RE: Herrera Residence Response to Comments (VoP)

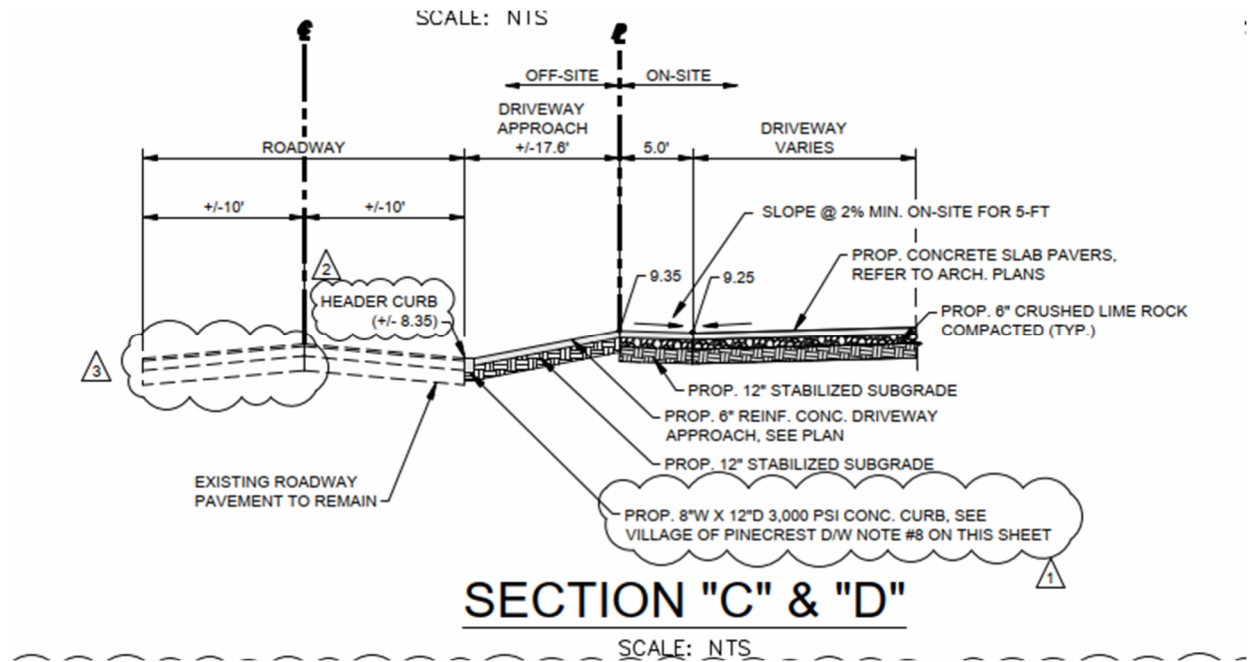
2.a. C-100: Provide sections adjacent to the driveways on the east and west sides of the property. (11-24-25: No sections provided)

Response: A section titled “Section C and D” was included in the Paving, Grading & Drainage Plan (Sheet C-100) submitted on 10/26/2025 to show in detail the grading of the two proposed entrance driveways as previously requested. See image below.

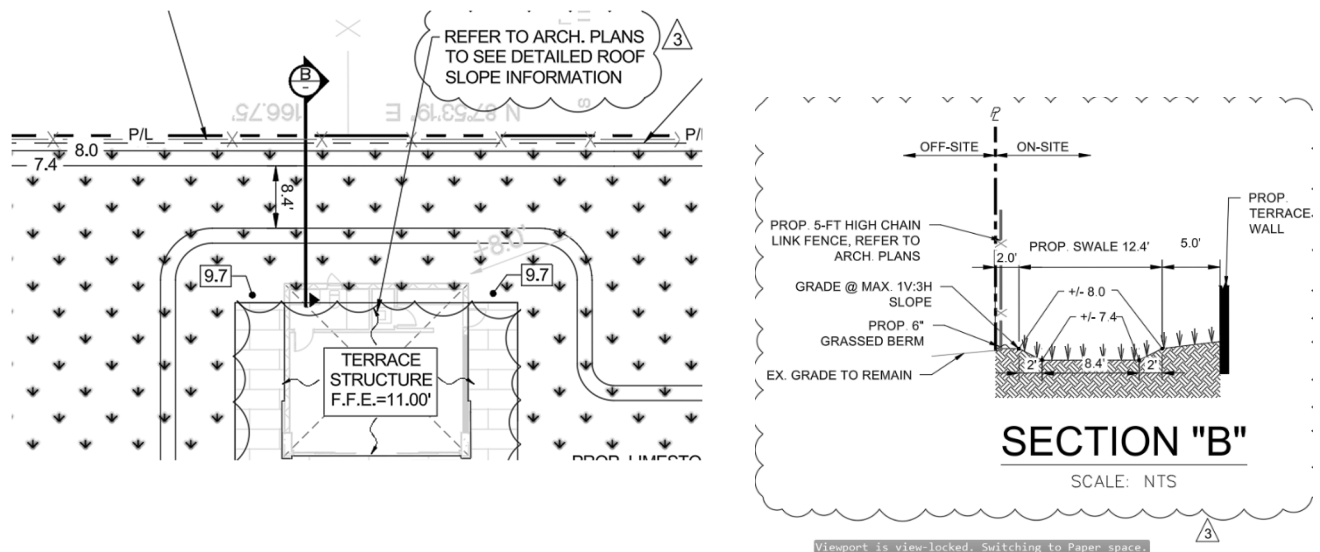
2.e. C-100: All sections: provide horizontal dimensions for all slopes and provide elevations at all changes in elevation. (11-24-25: this section is 13' wide in total – so there is no flat bottom as shown).

Response: The section being referred to in the above comment is “Section B”. See plan view and image view of section B below. The swale measures 12.4' , from which 8.4' are the flat bottom, and the remaining 4' are the side slopes graded at 3:1 from elevation 7.4' to 8.0'.
